## **REQUEST FOR TENDERS No. 26-013**

### **Lions Community Park – Infield Improvements**

#### **Addendum 1**

**Access and Staging Area**

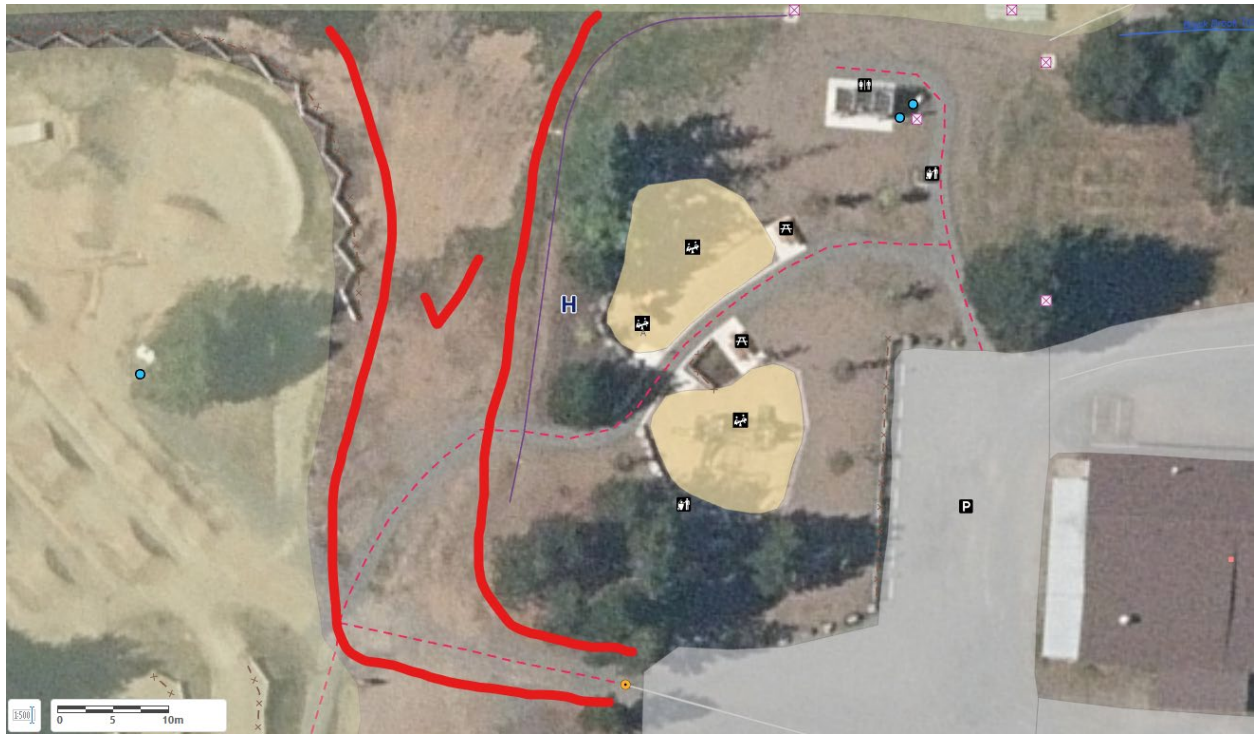
Also, the gravel parking area directly adjacent to the pump track, is the largest area for trucks to be able to enter and potentially turn around, will that entire area be part of that construction laydown area? i.e. will we be allowed to have truck using it for turn around and dumping and will we be allowed to use it for material storage?

It seems to us best access would be to run machinery in near pump track by removing bollard. We don't envision dump trucks getting any closer to the actual ballfields themselves, or is there better access somewhere else? If we use this access, efficiency will dictate using a large loader like a Deere 444, would something of that size be allowed to traverse field?

- The gravel parking area adjacent to the pump track may be used as the primary staging, turnaround, and material stockpile area.
- Below is a sketch identifying the exact extent of the approved access zone.
- Access through the bollard near the pump track is appropriate and anticipated as the preferred route.
